Agenda
Village of Arlington Heights
Design Commission
Community Room, 3rd Floor

Arlington Heights Village Hall
33 S. Arlington Heights Road
Arlington Heights, IL 60005
December 11, 2018
6:30 PM

MINUTES OF
THE VILLAGE OF ARLINGTON HEIGHTS
DESIGN COMMISSION MEETING
HELD AT THE ARLINGTON HEIGHTS MUNICIPAL BUILDING
33 S. ARLINGTON HEIGHTS RD.
NOVEMBER 27, 2018

NOTE:
THE EXTERIOR VENT TERMINATIONS
OF THE 90+ FURNACE AND FAN ASSIST
WATER HEATERS SHALL BE THROUGH
THE ROOF OR TOWARD THE REAR OF THE
HOUSE AND NOT LESS THAN 15' TO ANY
LOT LINE.

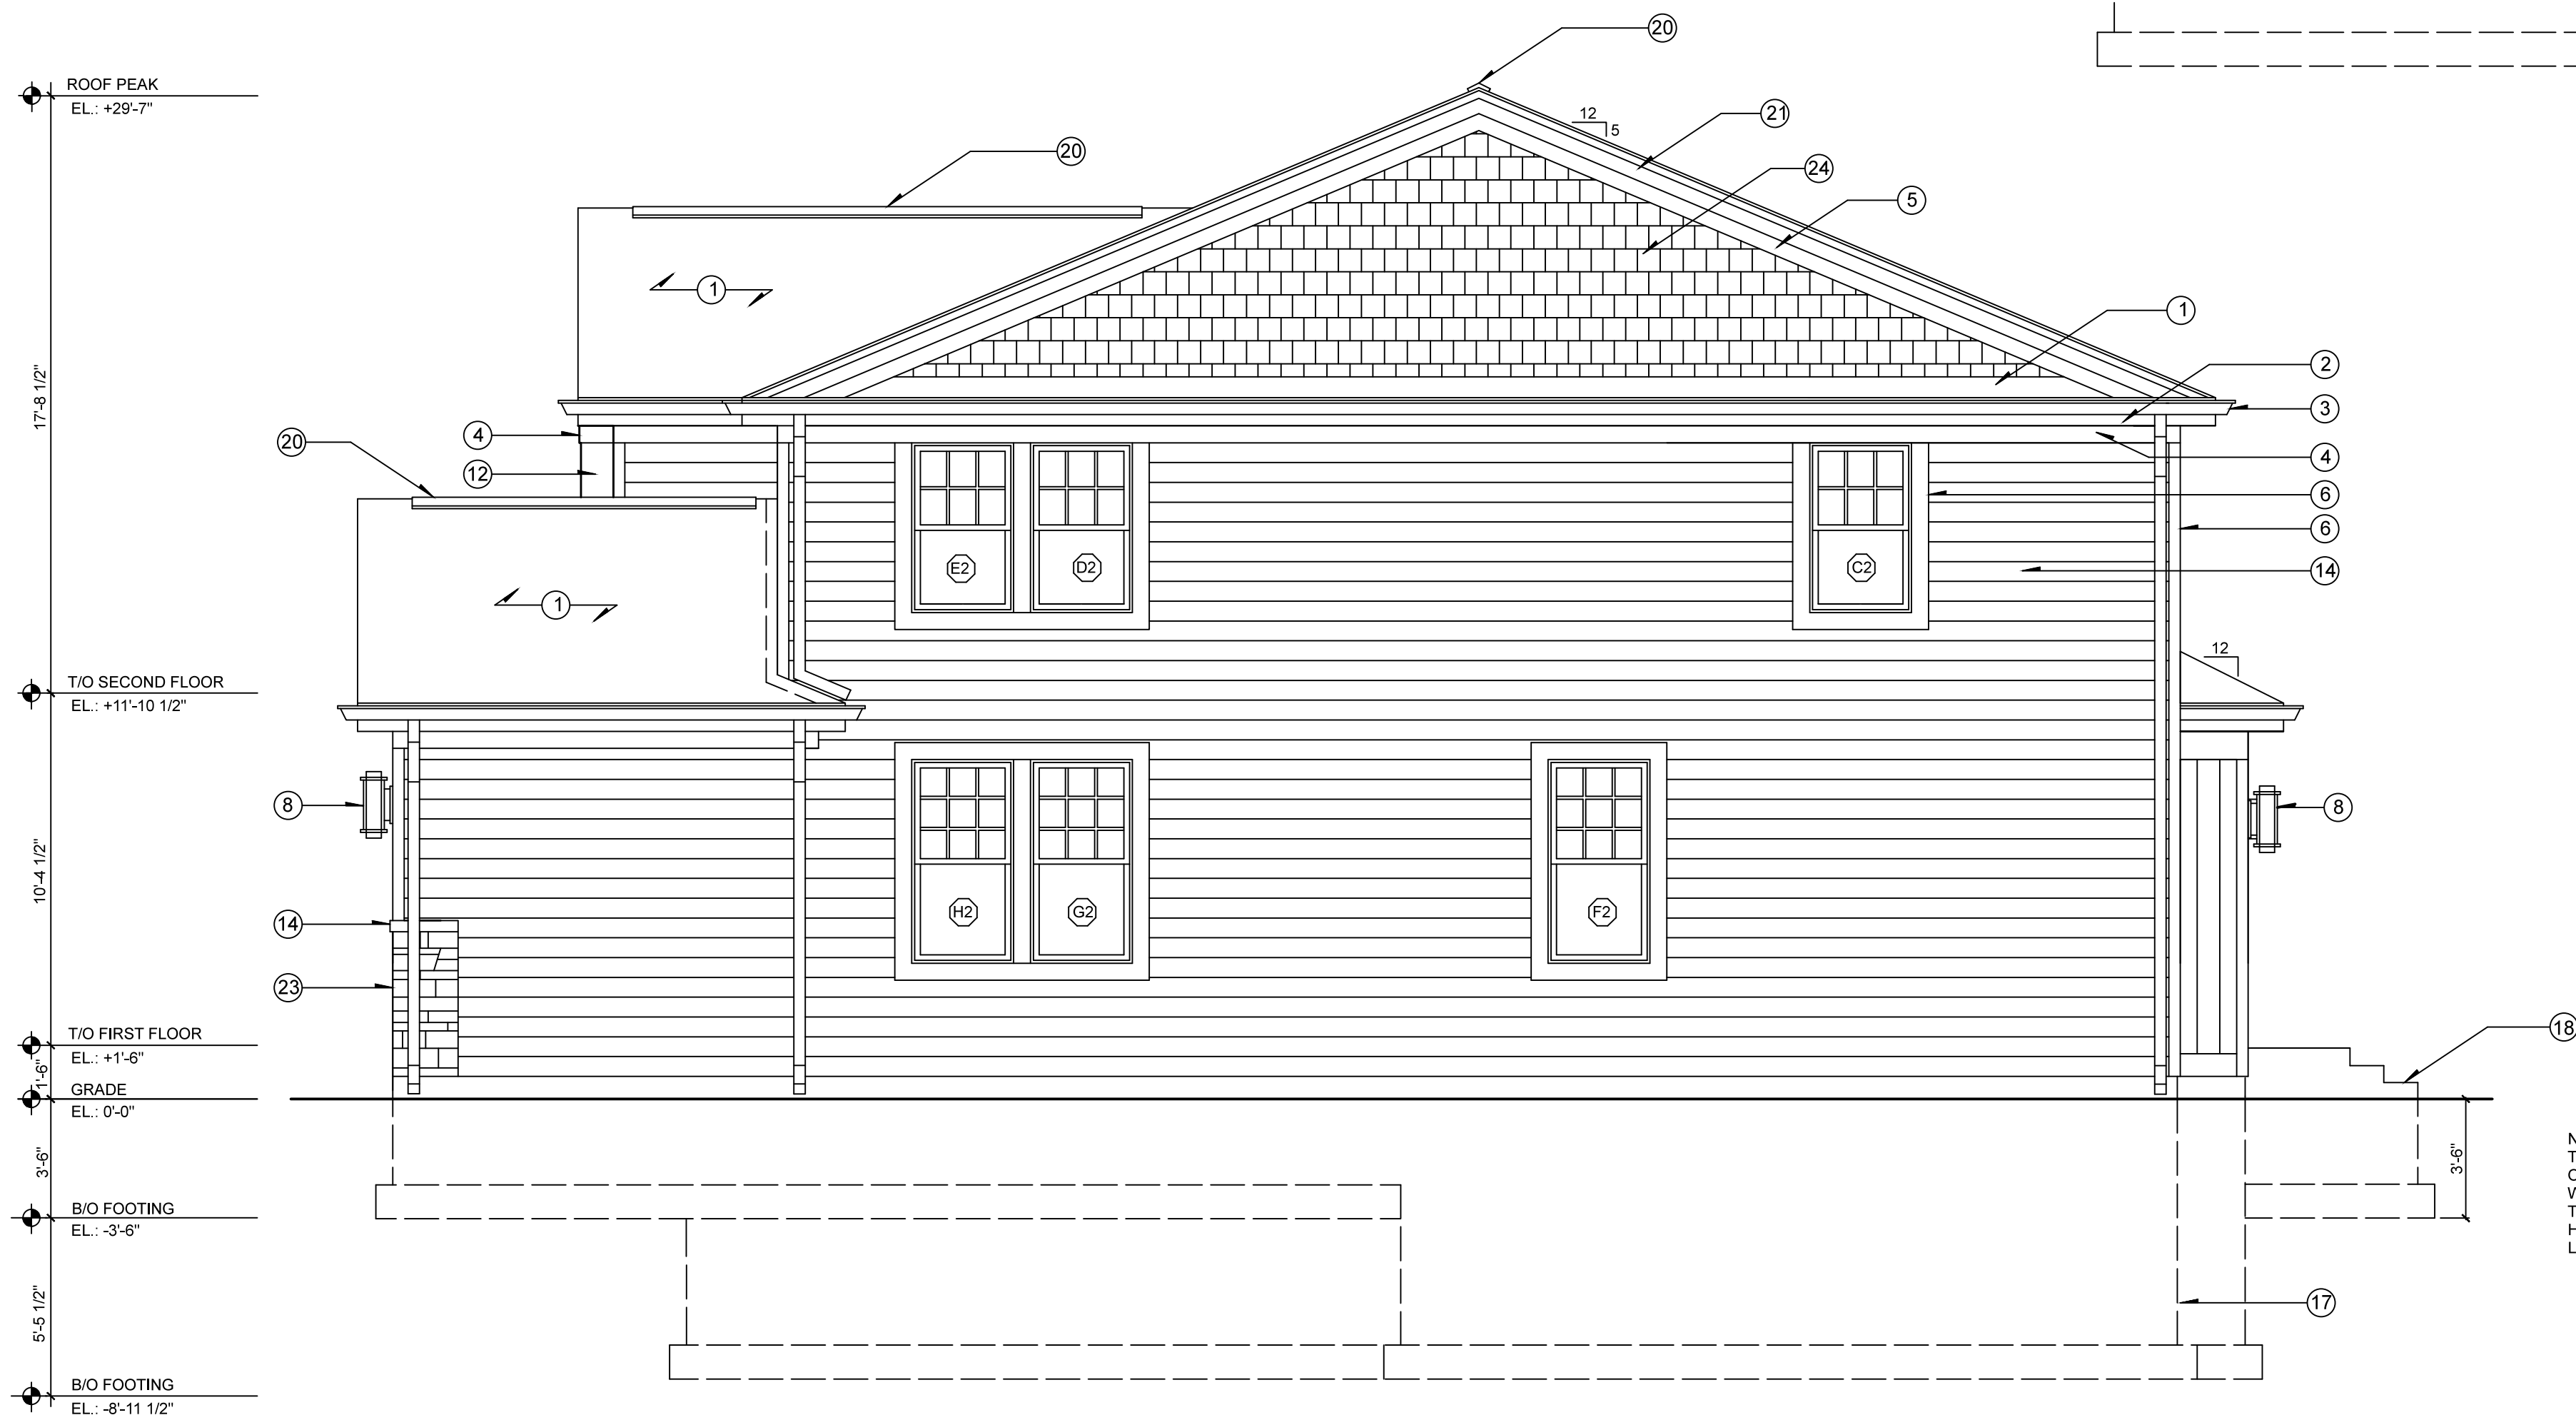
Overall, the proposed design is nicely done and is consistent with other newer homes approved in this neighborhood. Features such as the single-story front porch and single-story garage roof help the design to fit in with the adjacent single-story homes. The low-pitched gables fit well with the low-pitched roofs on the adjacent homes. The only comment on the design is that the proposed gray mist siding color is quite bright and cool as compared to the color tones of the other houses on the street. Consider a warmer gray siding color to better fit with the character of the neighborhood.

It is recommended that the Design Commission approve the proposed new single-family residence to be located at 534 W. Ridge Court. This recommendation is subject to compliance with the plans received on 11/8/18, and the following:

ENTRANCE IDENTITY SIGNAGE ON ARLINGTON HEIGHTS ROAD

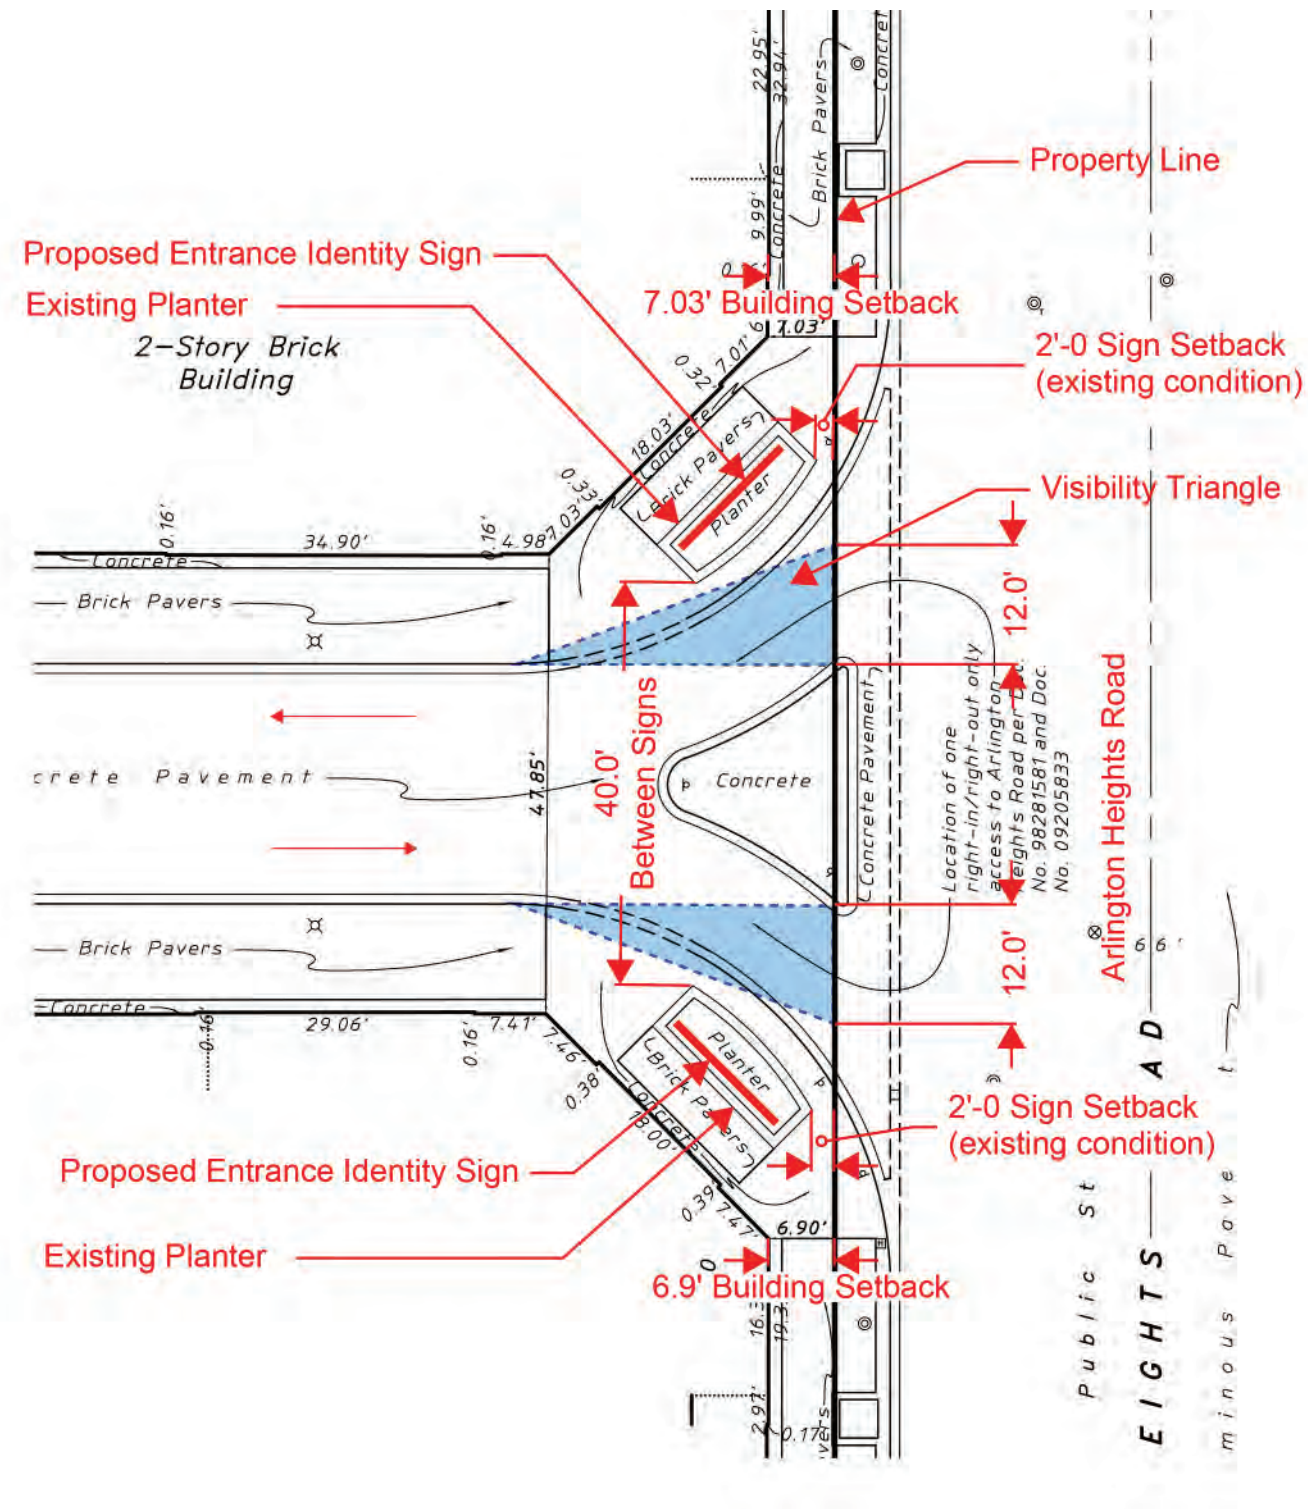
2. **Entrance Identity Signage on Arlington Heights Road.** There are two existing raised planters flanking the entrance driveway from Arlington Heights Road. Two new ground signs are proposed to be installed within these planters to highlight the entrance to the shopping center. Variations are required to allow two ground signs, where only one ground sign is allowed per street frontage, as well as to allow 40 feet separation between the signs, where 800 feet is required.

- The ground signs facing Arlington Heights Road will help to guide customers into the development, and the request for two signs is justified based on the existing layout of the entrance drive and planters. The signs are small and tastefully designed. Consider adding external illumination so that the signs will be visible in the evening.

COURTYARD SHOPS DIRECTORY SIGNAGE

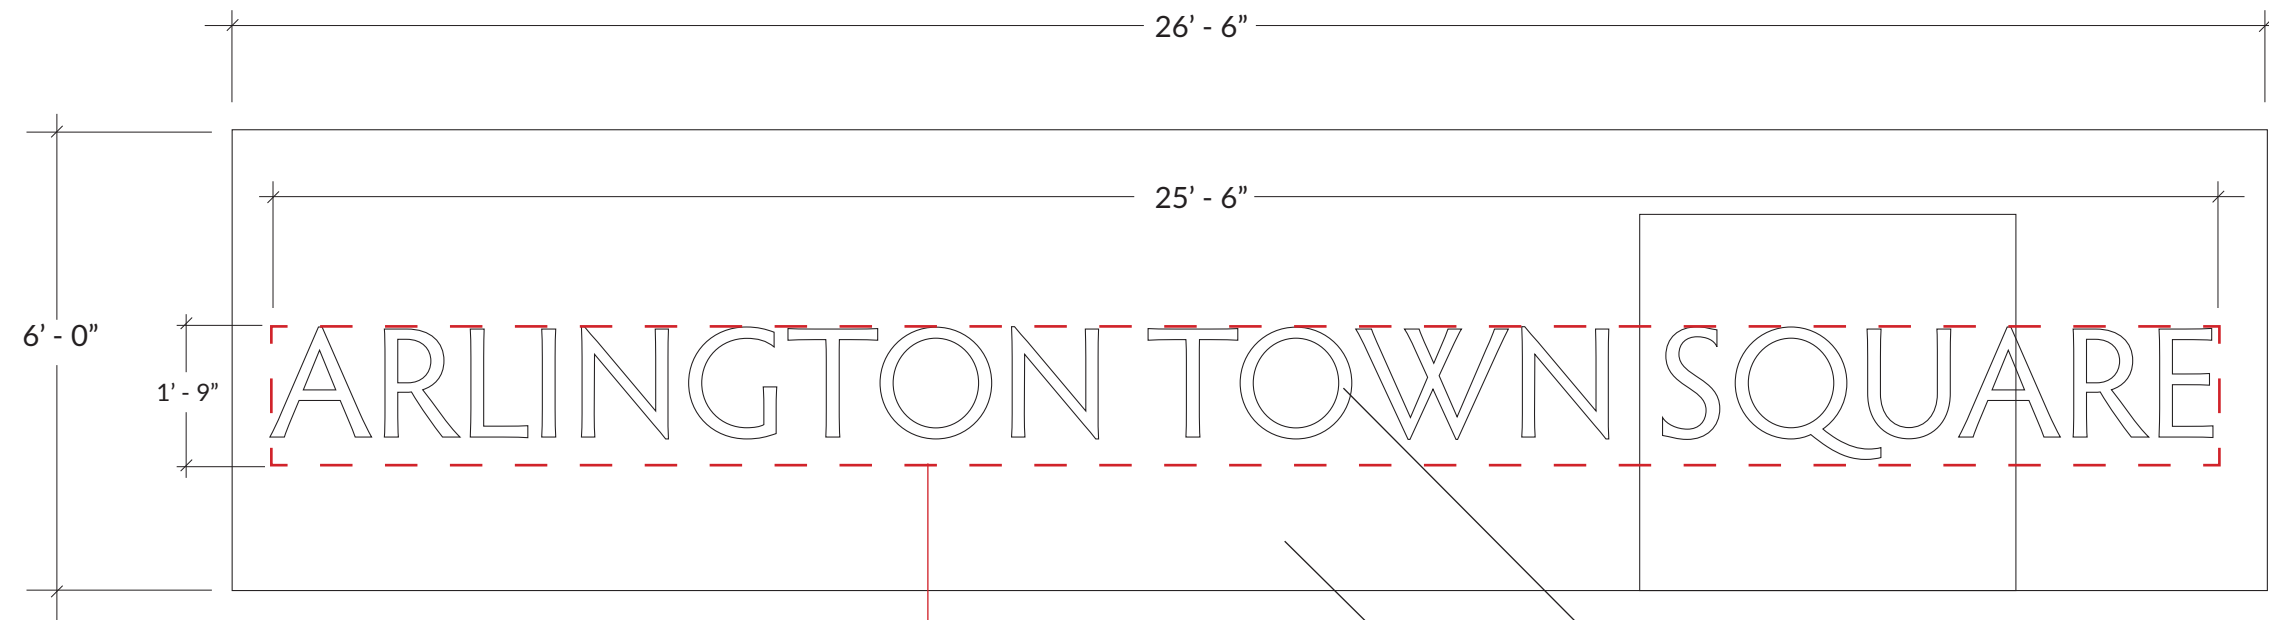
4. **Courtyard Shops Directory Signage.** There is an existing 13 sf wall-mounted "COURTYARD" directory sign at the entrance to the south courtyard that was approved by variation in 2004. A new internally illuminated larger 67 sf directory sign is proposed to replace the existing sign, so the existing variation needs to be amended to allow the proposed larger sign.
